ADDENDUM #1

**GUILFORD COUNTY SCHOOLS
Roofing Project: Jamestown Elementary School
Jamestown, NC
RTD Project 4-R12-13037-DPMOSI
Date: January 22, 2014**

Sheet
A4

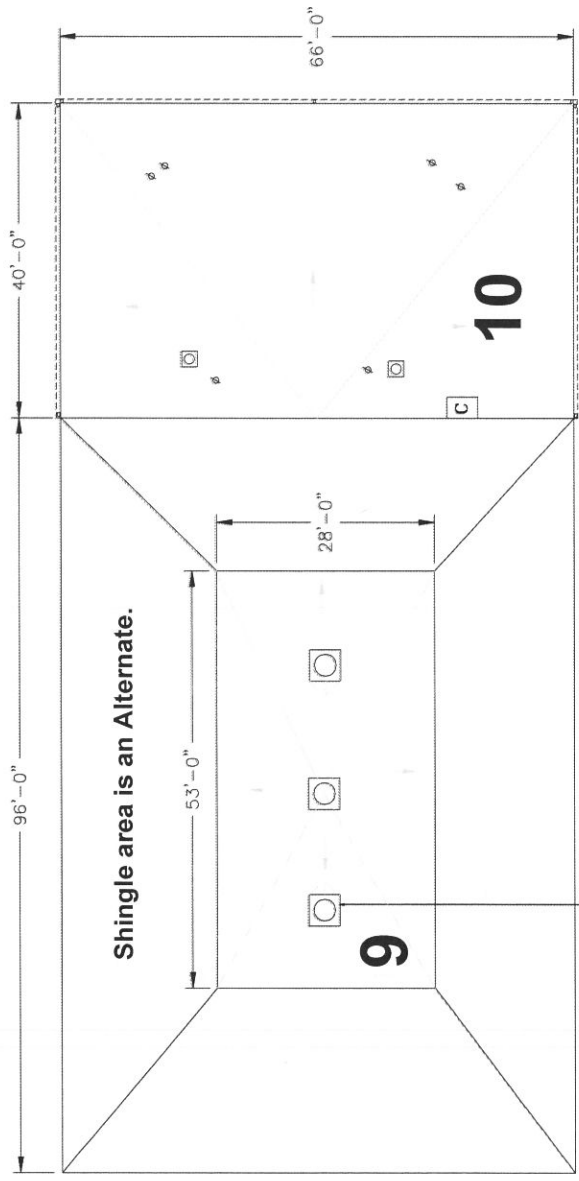
3. An additional add/alternate for the steep sloped portion of Roof Area 9 has been added to the scope of work. This is an add/alternate for consideration that removes the shingle roof, and installs a 2-ply modified roof assembly over the concrete plank substrate. The intent is for this roof to be included within the total project 20 year NDL warranty, as specified.

Shingle area is an Alternate.
Contractors to verify all dimensions per
specifications.

- A. Completely remove the existing shingle roof, ply felts, and any flashings down to the concrete deck structure and properly dispose of. (Note - the gutters and downspouts are being re-used - take care during removal)

- B. Remove all debris and any residual asphalt, or other materials that would alter or affect the application of the new materials.
- C. Repair any openings, holes or deficiencies in the concrete deck that would allow for debris or asphalt to run into the building.

- D. On the concrete decks, prime the concrete per manufacturer requirements.
- E. Install the specified baseply roof membrane via Torch Application or Peel and Stick method depending on manufacturer requirements. Note, some manufacturers will require backnailing.

- F. Install new 24 ga. Kynar finished edge metal per the specifications, standard color to be selected by owner. A 1" minimum ventilation air space shall be required at the top edge closure piece. Re-use the existing gutters and downspouts.

- G. Install the specified cap sheet via Torch Application or Peel and Stick method depending on manufacturer requirements. Note, some manufacturers will require backnailing.

- H. Provide a 20 year NDL type warranty as specified.

6 GRAVEL STOP EDGE
N.T.S.

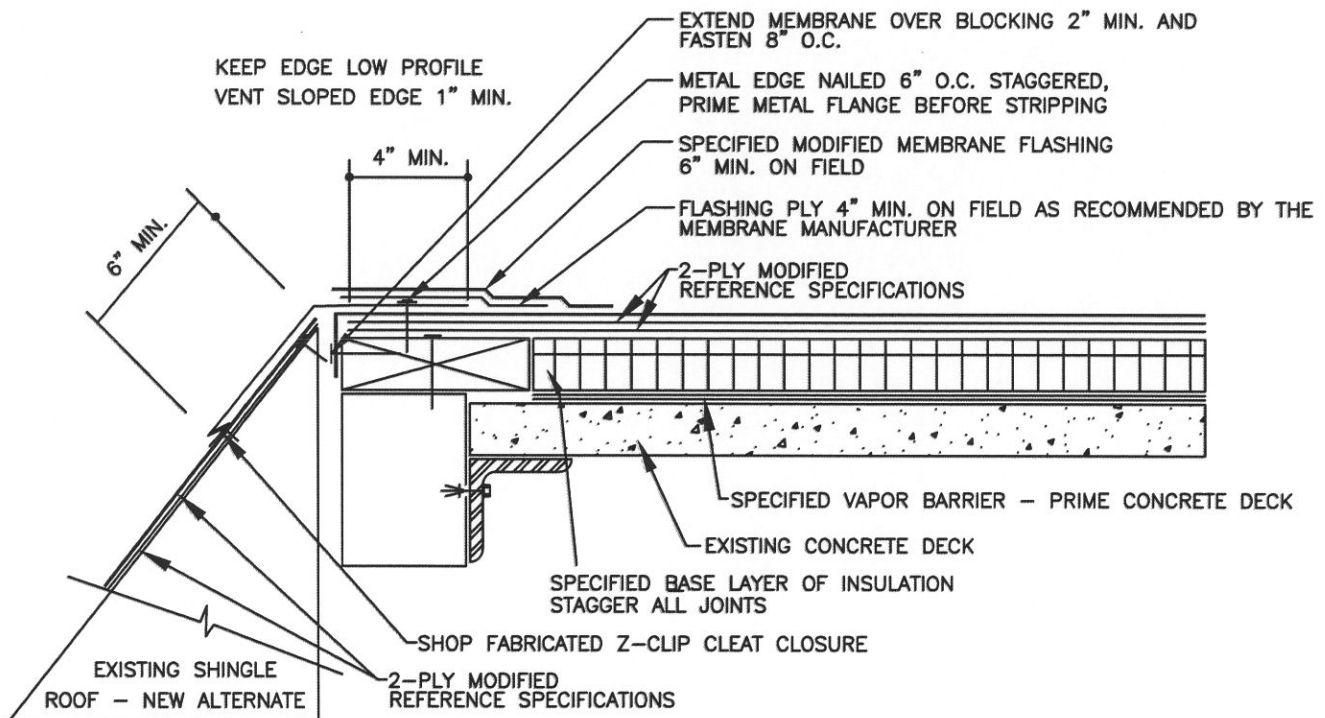
CONTRACTOR SHOULD PLAN ON INSTALLING NEW WOOD NAILERS AT ALL LOCATIONS.
